ADDENDUM NUMBER ONE (1)

Issued 04/24/2025

Project: INNER PERIMETER ROAD UTILITIES EXTENSIONS

Project No. 25-05-702

STANDARD
CONCRETE & METAL PIPE CULVERTS
SHEET 2 OF 3
(FILL HEIGHTS FOR CONCRETE & CORRUGATED METAL PIPE)

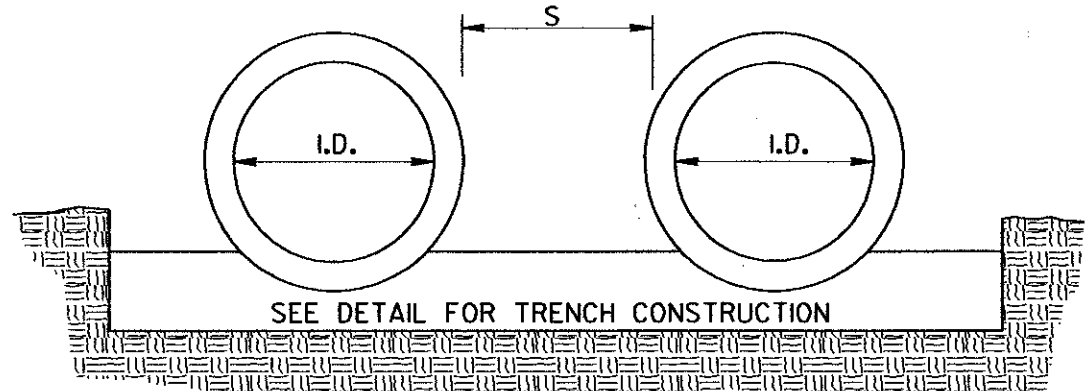
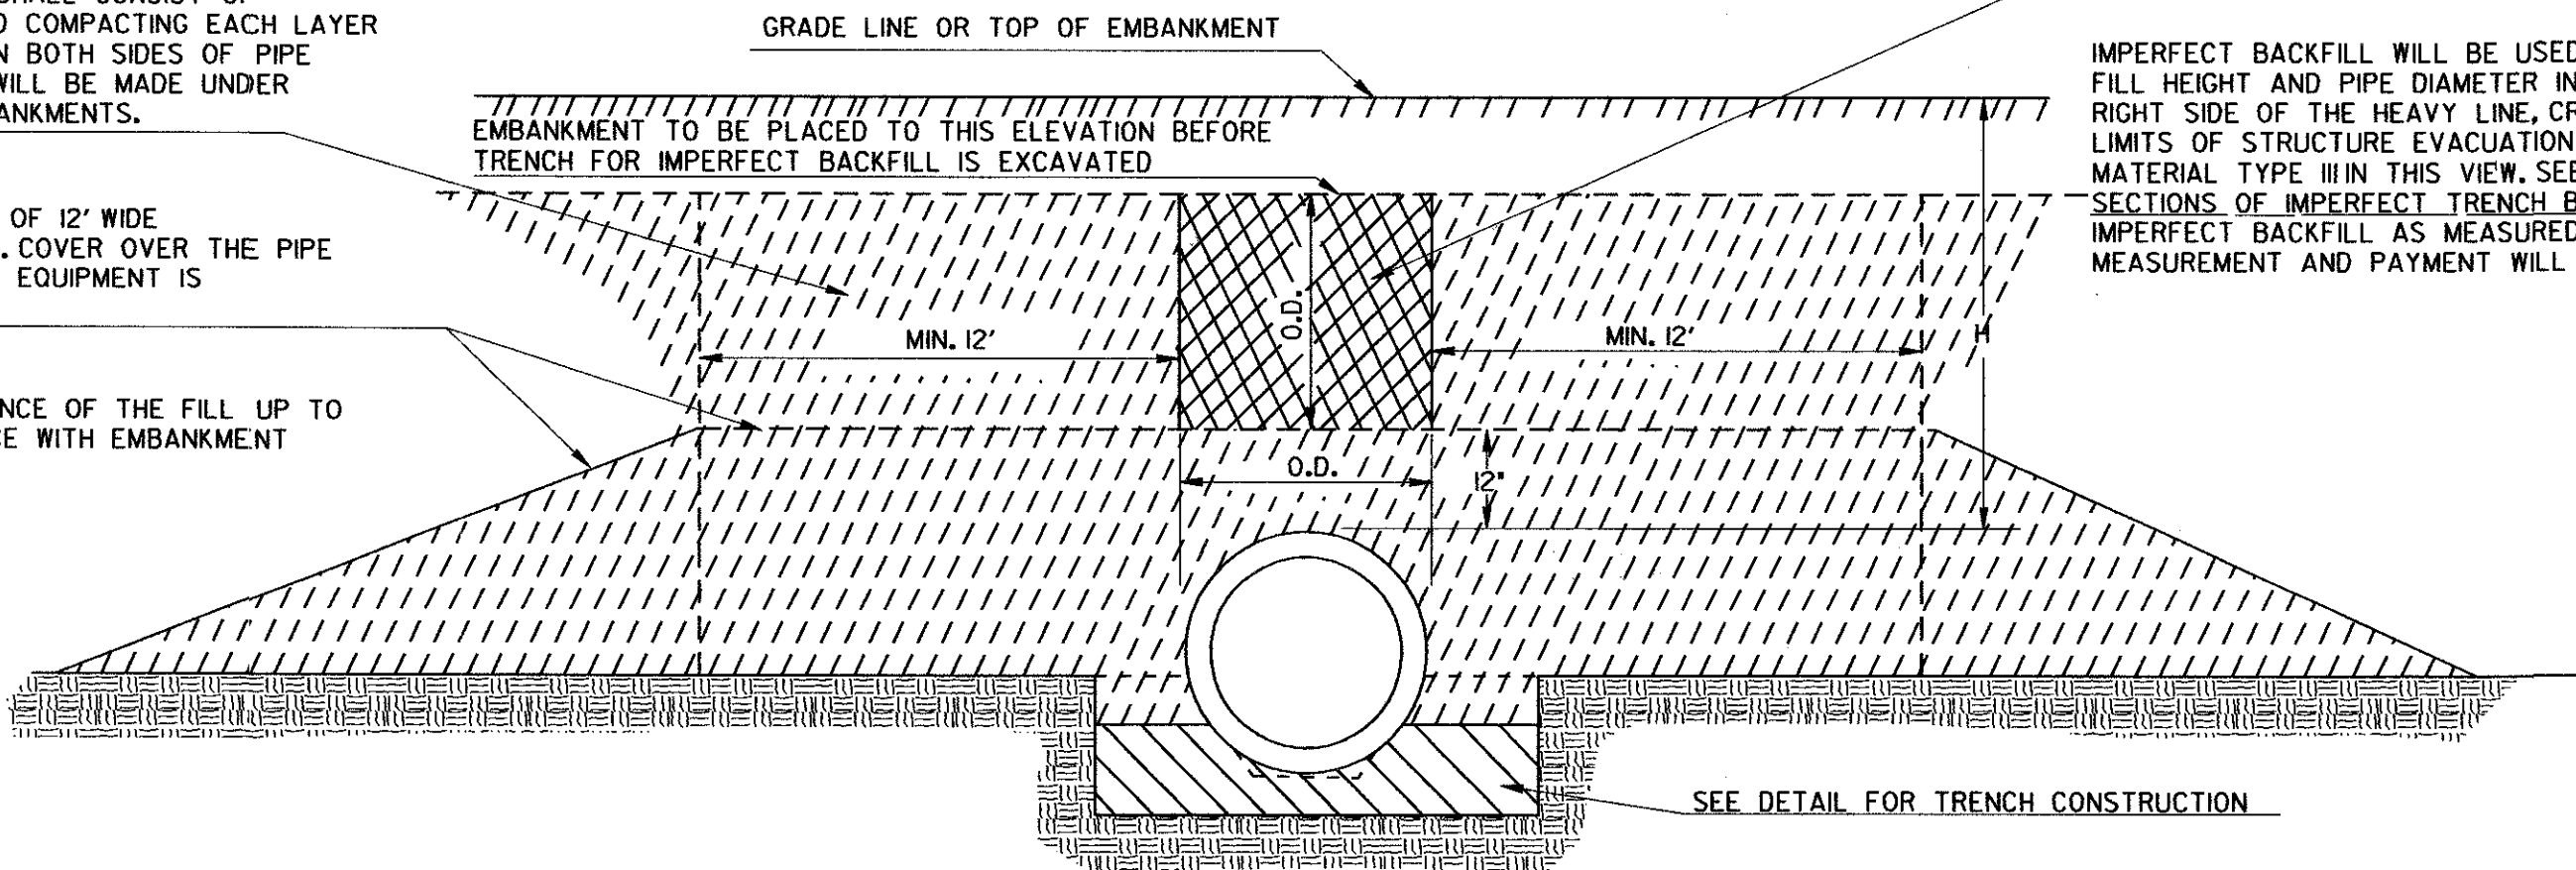
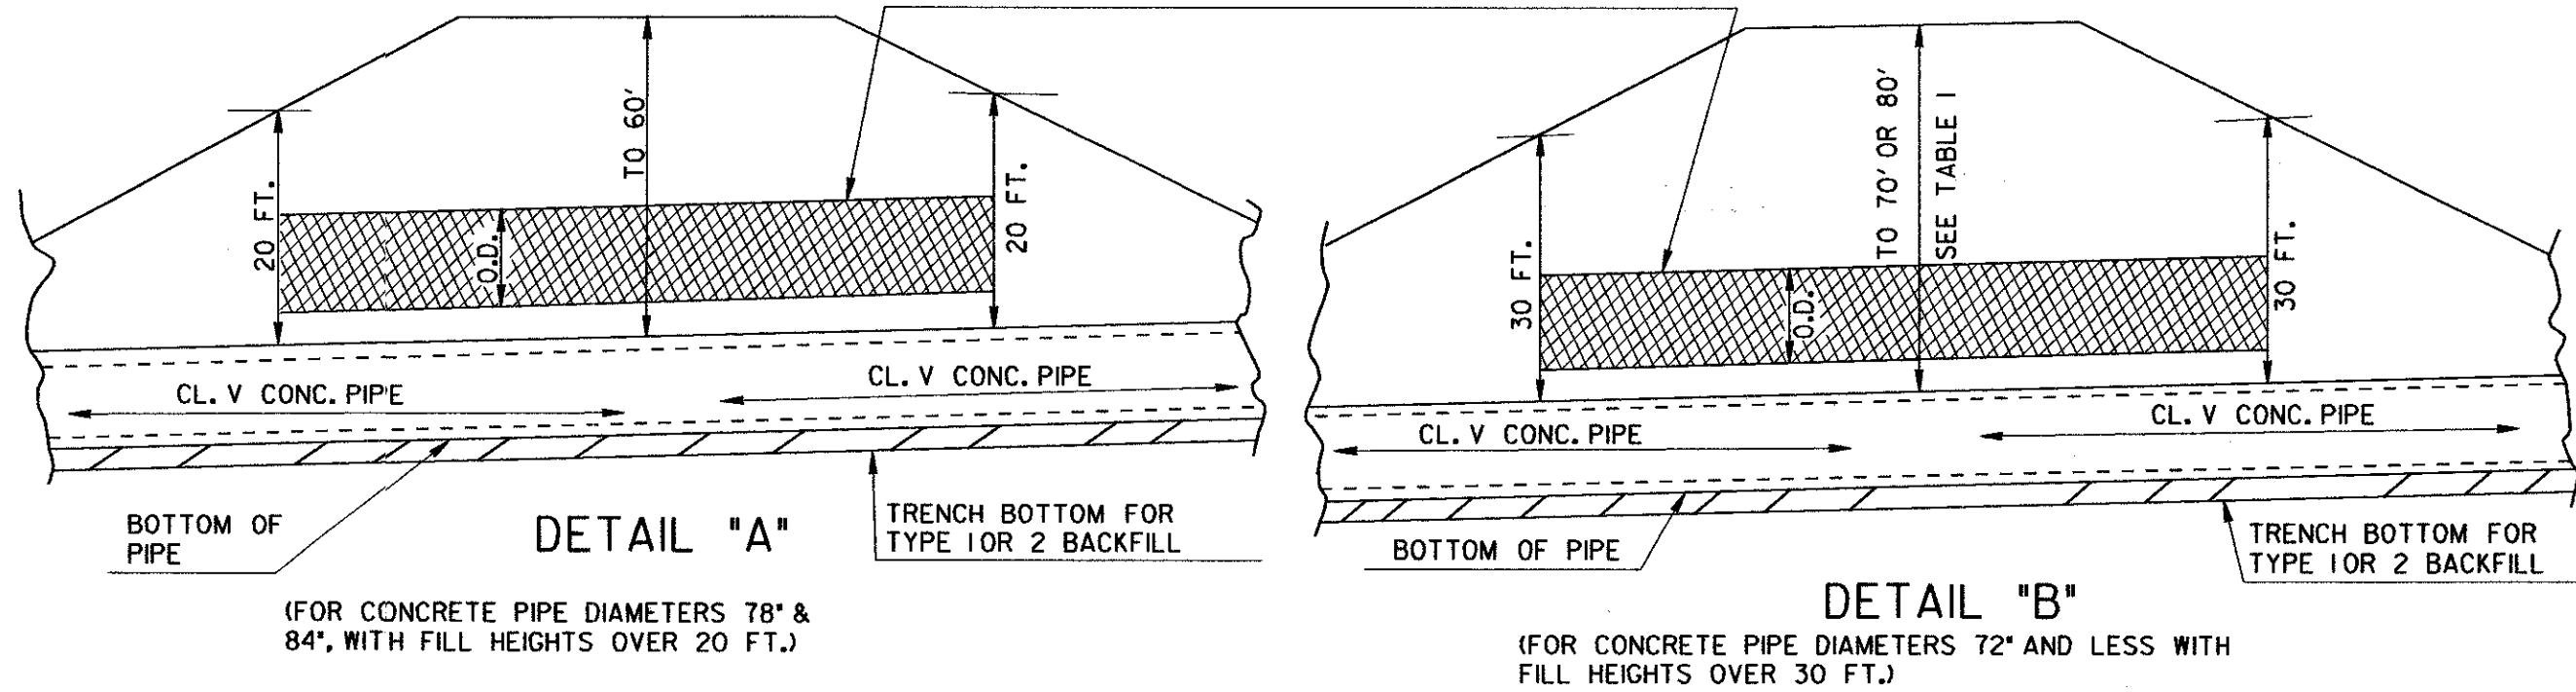
6. Bid item 500-b, remove and replace 18" RCP, is not called out on plans. Is this driveway at Ace Electric? New pipe required? YES; THIS WAS NOT CALLED OUT SPECIFICALLY ON THE PLANS, BUT ON SHEET 1, WHERE THE NEW GRAVITY SEWER CROSSES THE EXISTING ACE DRIVEWAY, IT IS IN DIRECT CONFLICT WITH THE EXISTING STORM PIPE. REMOVE AND REPLACE THAT STORM PIPE IN ORDER TO PUT IN THE GRAVITY SEWER. Does new pipe have to be DOT stamped? GUY RENTZ OF THE GDOT AREA OFFICE STATES: "Pipes have to meet the GDOT standard (1030D2) added standard (1030D) . No DOT inspection stamp required. (attached standard)"
